**PLANNED UNIT DEVELOPMENT &
PLANNING APPROVAL STAFF REPORT****Date: May 15, 2008****NAME**

Weinacker's Montessori School, Inc.

LOCATION227 Hillcrest Road
(East side of Hillcrest Road, 625' ± South of Cedar Bend Court)**CITY COUNCIL
DISTRICT**

Planning Approval to amend a previously approved Planning Approval to allow a school in an R-1, Single-Family Residential District, and Planned Unit Development Approval to amend a previously approved Planned Unit Development to allow multiple buildings on a single building site.

SITE PLAN

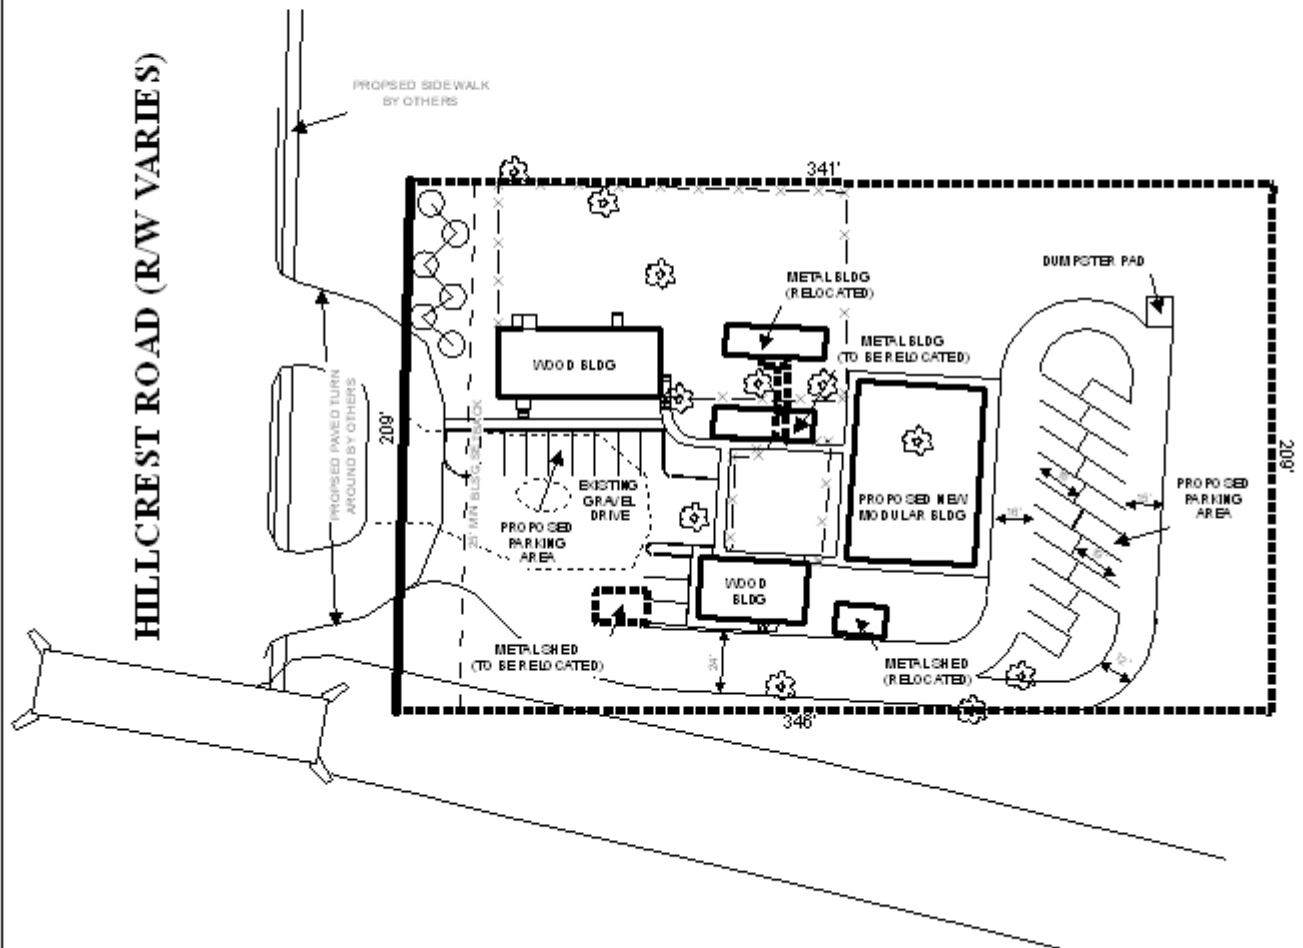
It appears that the plans depict general compliance with the overall minimum requirements of the Zoning Ordinance. It should be pointed out that a dumpster will be placed at the rear of the proposed parking area, and that detention will be accommodated in the parking area or underneath the parking area. The parking areas should be paved, and the parking and circulation areas should be curbed to prevent vehicles from driving into landscape areas: where handicap parking is provided, bumper stops should be used to keep vehicles from entering sidewalks that are flush with parking areas.

Also, specifically regarding the one-way circulation of the rear parking area, the one-way directions should be marked with arrows, and a sign should be posted stating “do not enter” on the exit drive from the parking area. Furthermore, the curved portions of the one-way circulation drive may need to be wider to accommodate the truck that will service the proposed dumpster: a width of 15-feet should be provided, and the radius of the curves should be indicated on the site plan.

The site plans should be revised to depict a fence or protection buffer strip along the North, East and South perimeters of the site, in accordance with Section 64-4.D.1. of the Zoning Ordinance.

- 2) Revision of the site plan to depict curbing and/or bumper stops for all parking and circulation areas in order to protect adjacent landscape and sidewalk areas;

- 3) Revision of the site plan to depict a minimum width of 15-feet for the one-way circulation drives, the marking of the drives with arrows and “do not enter” signage to ensure correct circulation, and the marking of the radius for the curved portion of the one-way drives;

- 5) Revision of the site plan to clearly depict a fence or protection buffer strip along the North, East and South perimeters of the site, in accordance with Section 64-4.D.1. of the Zoning Ordinance;

- 7) Placement of a note on the site plan stating that the site is limited to the existing curb-cut onto Hillcrest Road, and denied access to the unopened public right-of-way on the Eastern boundary of the lot, with the size, design and location of the curb-cut to be approved by Traffic Engineering and in compliance with AASHTO standards;
